## Product Change Notification: ALAN-03HRHE038

CCB 6777 and 6777.002 Final Notice: Qualification of ANAP as an additional assembly location for selected ATSAM4N16C, ATSAM4N8C, ATSAM4S16C, ATSAM4S16CA, ATSAM4S2C, ATSAM4S4C, ATSAM4S4CA, ATSAM4S8C, ATSAM4SA16C, ATSAM4SD16C, ATSAM4SD32C, ATSAM4S4A, ATSAM4S2A and ATSAM4N8A device families available in 100L and 48L LQFP (14x14x1.4mm and 7x7x1.4mm) packages.

### **PCN# ALAN-03HRHE038**

*For 100L LQFP (14x14x1.4mm ) package*

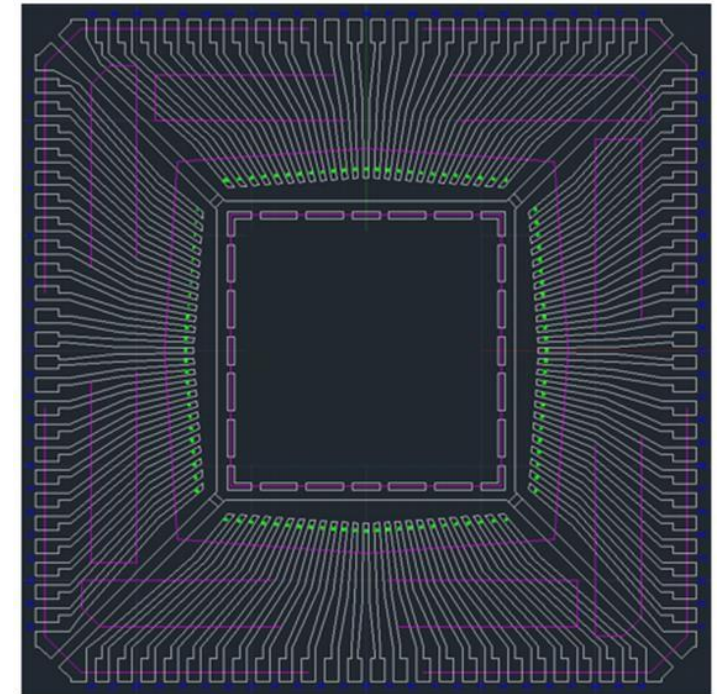
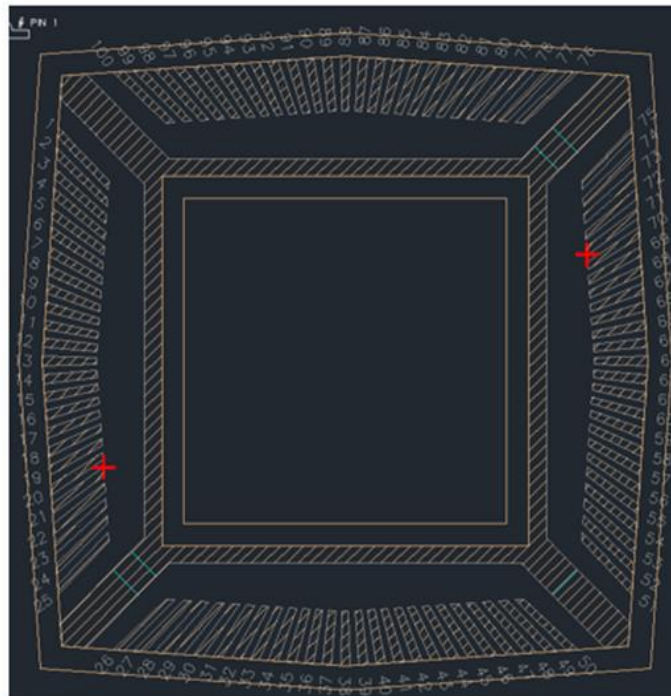
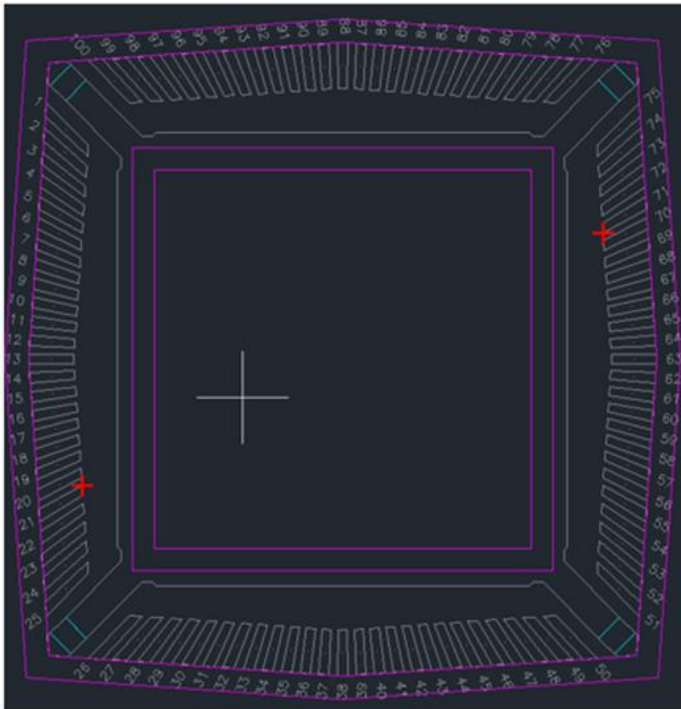
Assembly Site	ATX Semiconductor (Shanghai)Co. Ltd (ASSH)		ATX Semiconductor (Shanghai)Co. Ltd (ASSH)		Amkor Technology Philippine (P1/P2), INC. (ANAP)
Wire Material	CuPdAu	CuPd	CuPdAu	CuPd	CuPdAu
Die Attach Material	2288A		2288A		3230
Molding Compound Material	CEL-9510HFL		CEL-9510HFL		G631HQ
Lead-Frame Material	C7025		C7025		C194ESH
Lead-Frame Paddle Size	240X240	180X180	240X240	180X180	256X256
Lead Lock	No		No		Yes
See Pre and Post change for Lead-Frame Comparison.

*For 48L LQFP (7x7x1.4mm) package*

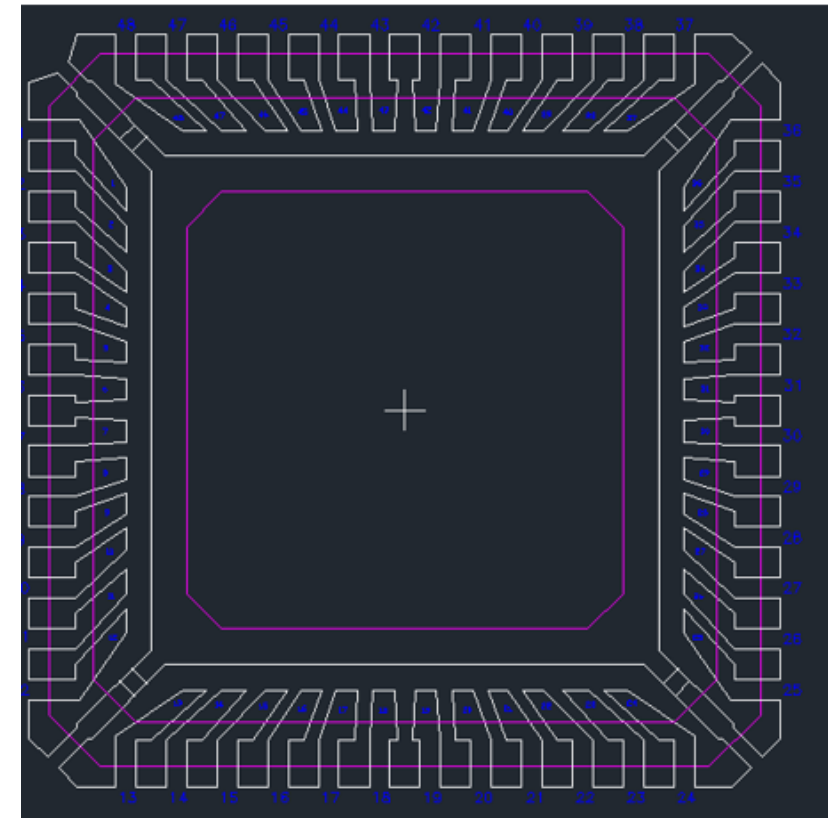
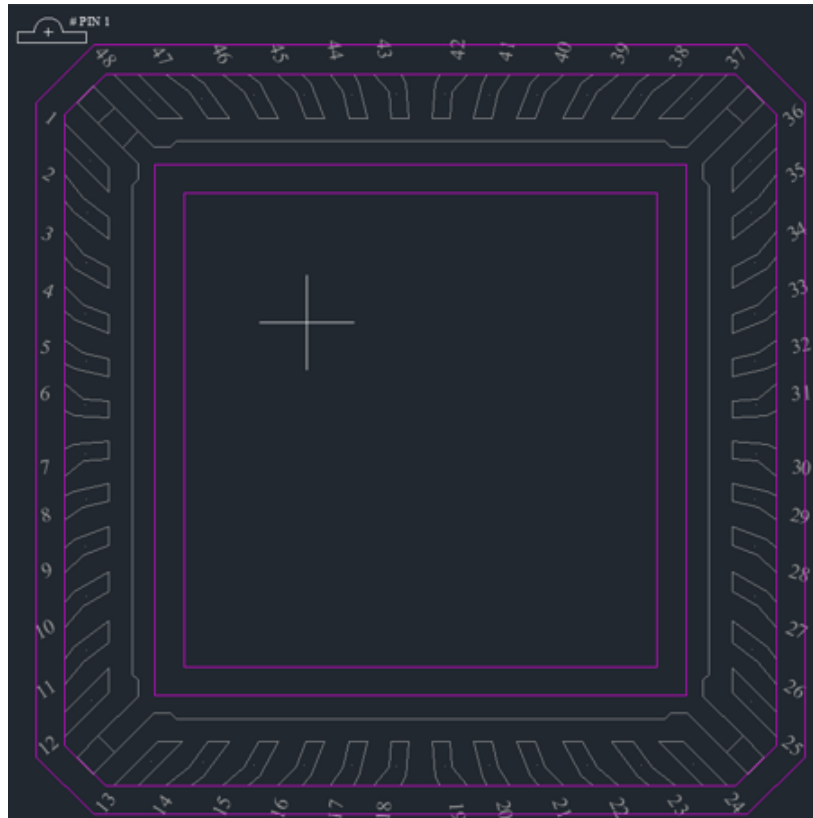
Pre Change	Post Change	
Assembly Site	ATX Semiconductor (Shanghai)Co. Ltd (ASSH)	ATX Semiconductor (Shanghai)Co. Ltd (ASSH)	Amkor Technology Philippine (P1/P2), INC. (ANAP)
Wire Material	CuPd	CuPd	CuPdAu
Die Attach Material	2288A	2288A	3230
Molding Compound Material	CEL-9510	CEL-9510	G631HQ
Lead-Frame Material	C7025	C7025	C194ESH
Lead-Frame Paddle Size	197X197	197X197	197X197
See Pre and Post change for Lead-Frame Comparison.
